DEVICE NAME: Collider Detector End Wall Hadron Module Lifting
Fixture

ENGINEERING NOTE NUMBER: 53

To: John Grimson
From: John Pawlak
Subject: Collider Detector End Wall Hadron Module Lifting Fixture

Below-the-Hook Lifting Device Engineering Note

F. Bending Stress at Center Beam

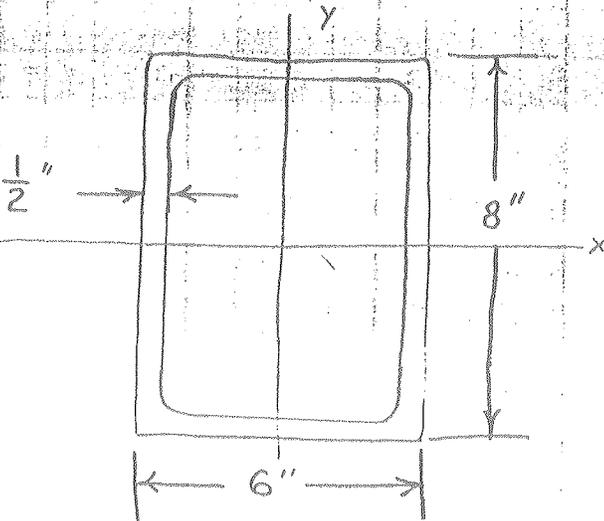
- 1) The cover sheet needs a manufacture date.
- 2) The cover sheet should probably have the fixture ID number (51) listed in the now empty space for the property number.
- 3) ANSI B30.20 states that the fixture should have the lifter weight, if over 100 LB, marked on the fixture.
- 4) ANSI B30.20 also states that "a lifter shall be designed to withstand the forces imposed by its rated load, with a minimum design factor 3, based on yield strength, for load bearing structural components." Chad consistently multiplied the yields by 0.6 to calculate allowables, a design factor of 1.6. He should really have multiplied by 0.33. I believe, however, that the computed stresses are still less than the new allowables:

$$\sigma_{\text{allow}} = 27.6 \text{ ksi}$$

$$\sigma_{\text{allow}} = 46 \text{ ksi} \cdot 0.33 = 15.3 \text{ ksi}$$

STILL O.K.
